CITY OF NEWPORT BEACH

April 12, 2017

Re: Request for Revision of the Preliminary FIRM and BFE
Docket No. FEMA-B-1673

Figure 10. Proposed Revised VE Zone Extent for Zone 17

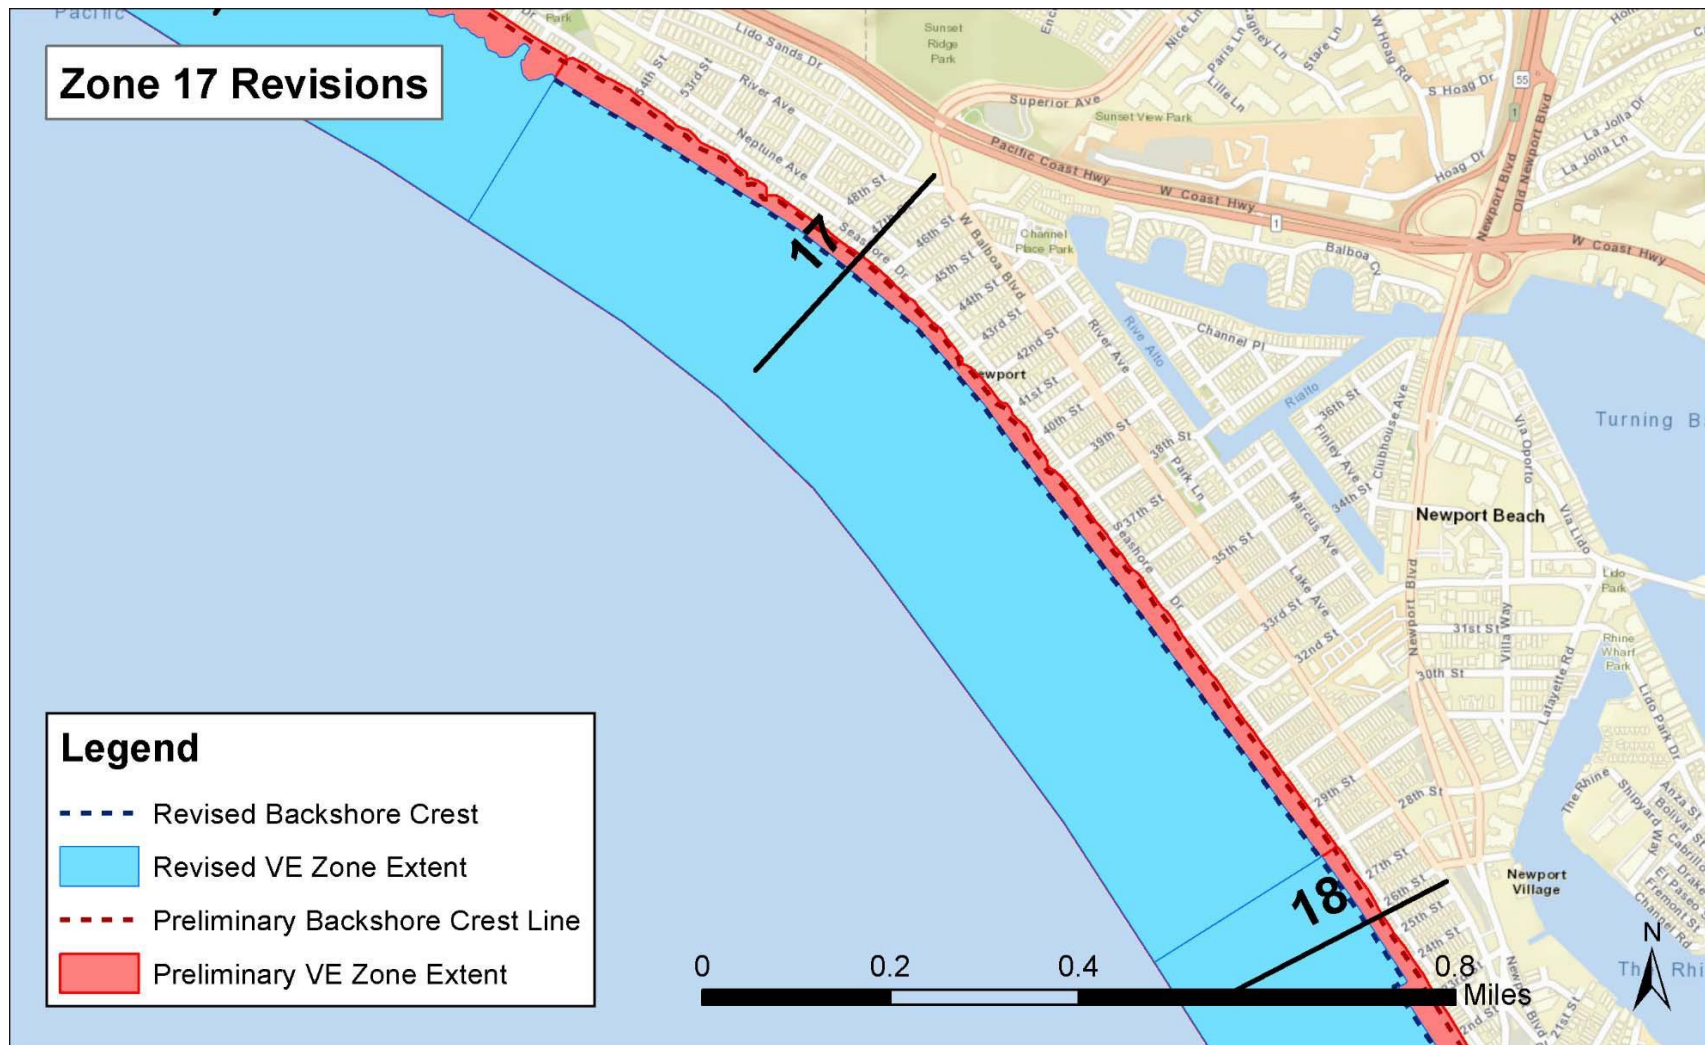
In Zone 17, both the revised and preliminary 1% TWLs overtop the foreshore beach crest and any backshore features. However, in the OPC Study, beach berms were not considered in the transect profile, so the semi-formal seawall adjacent to private properties was selected as a backshore feature. In the revised analysis, the approximate location of beach berms was used to define the location of the backshore feature. The location of beach berms was approximated from Figure 8a, which demonstrates the location of berms built in this region of Newport Beach. The absolute elevation of the berm crest was not required, because we assumed that the berm fails during the 1% event and overtopping analysis is conducted using the bare earth elevation. Thus, in Zone 17, the revised VE Zone extent is based on selecting a different backshore feature for overtopping analysis. Figure 10 shows the revised versus preliminary VE Zone extents.

1. Revise the FIRM for the AE Zone to the proposed revised flood map shown in Figure 4b, which was developed based on more accurate 2D hydrodynamic modeling.
2. For the VE Zone, revise the BFEs to those shown Table 1. The proposed revised BFEs were developed based on more accurate use of the available beach slope data. In addition, revise the preliminary FIRM for Zone 16, 17, 18, 20, 22 and 23/24 to the proposed revised VE Zone extents shown in Figures 9 to 14.

Figure 12. Proposed Revised VE Zone Extent for Zone 20

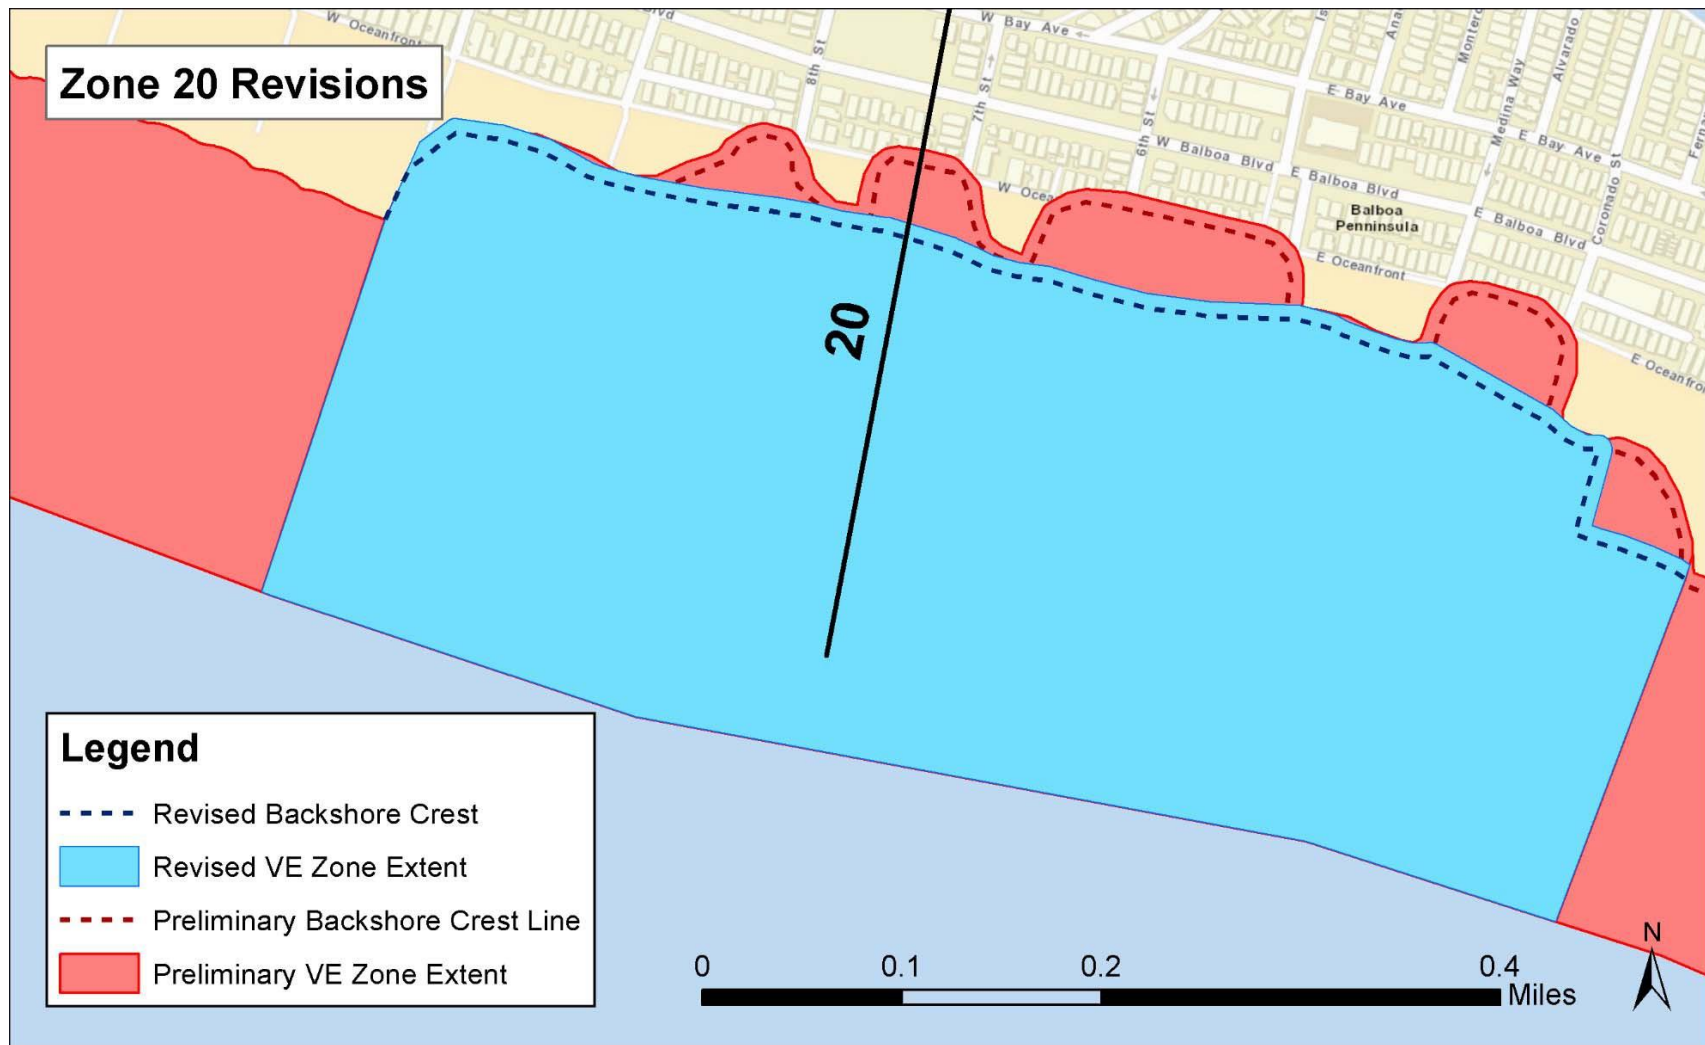
In Zone 20, both the revised and preliminary 1% TWL overtop the foreshore and any backshore features in the beach profile of transect 20. In the OPC Study, the backshore features appear to be the private seawall between sand dunes, and the base of the sand dunes elsewhere within the shoreline reach. In our study, we used Figure 8a to estimate the location of beach berms in Zone 20. The beach berms were again selected as the backshore feature in Zone 20. Figure 12 shows the revised versus preliminary VE Zone extent for Zone 20.

Figure 14. Proposed Revised VE Zone Extent for Zone 23/24

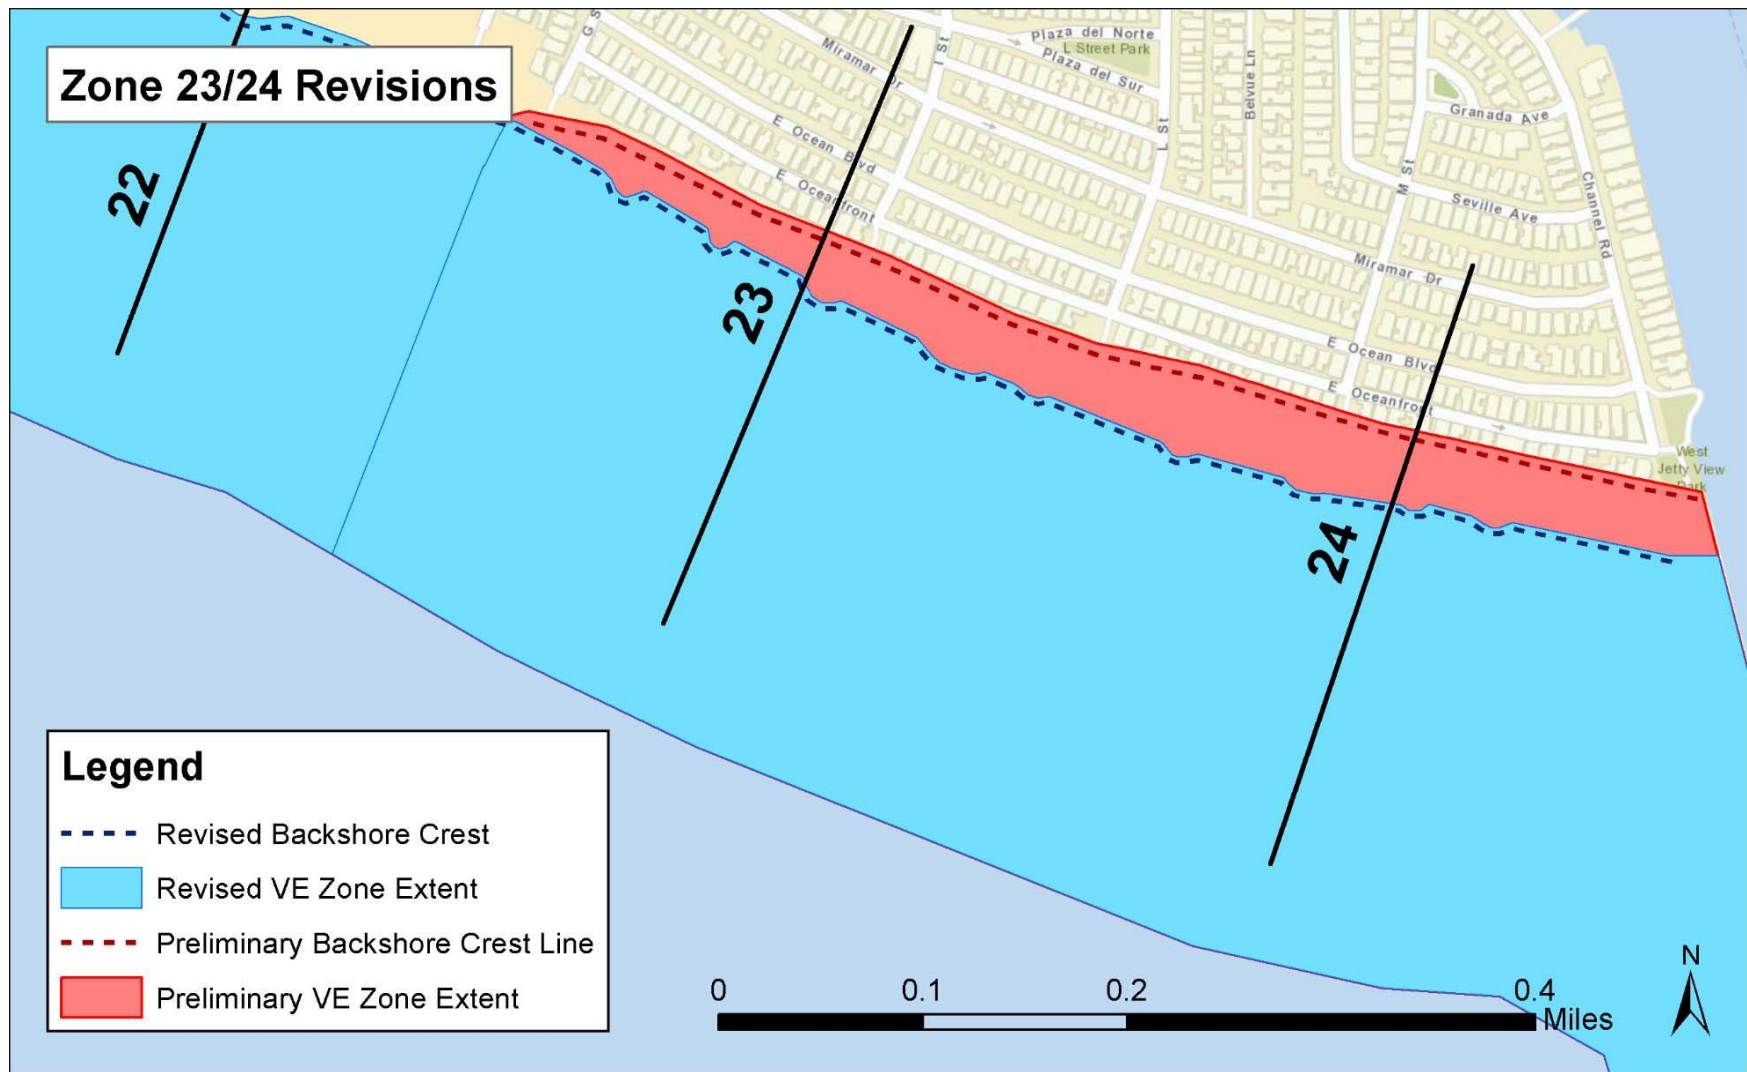
In Zone 23/24, which includes two different transects, both the preliminary and revised 1% TWL overtop the foreshore beach crest and backshore features. In the OPC Study, a backshore dune was selected as the backshore feature for transect 23, while a private seawall was selected as the backshore feature for transect 24. We used the approximate location of beach berms to define the location of the backshore feature for both transects 23 and 24. In this study, the overtopping extent from the approximate location of the beach berms was calculated using runup parameters from both transects 23 and 24. The average overtopping extent of transects 23 and 24 was used to define the VE Zone Extent for Zone 23/24. The revised versus compared VE Zone extent is shown in Figure 14.
